M3202A-01

Modification Recommended Service Note

M3202A PXIe Arbitrary Waveform Generator

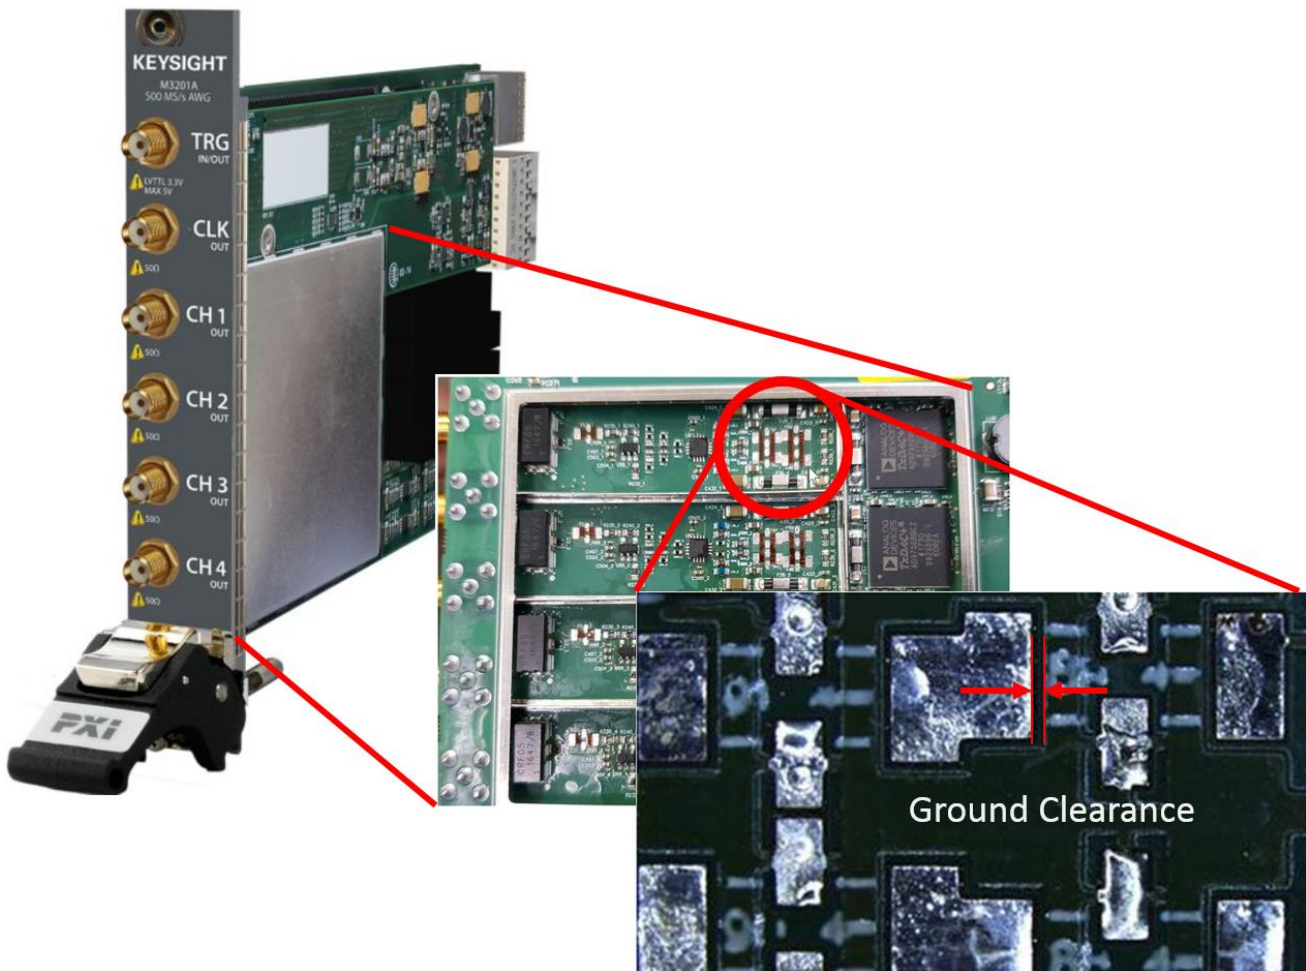
- 1. A possible short circuit between the filter output pad and the PCB ground plane due to insufficient ground clearance in the PCB design.
- 1. The performance of the filter changed sometime in 2017 which was not picked up by Keysight. This resulted in unstable DC offset performance after being in operation for some time.

The ground plane clearance problem can be seen below:

These problems have been fixed in all modules, M3201A & M3202A, M3300A & M3302A from MY57510001 onwards.
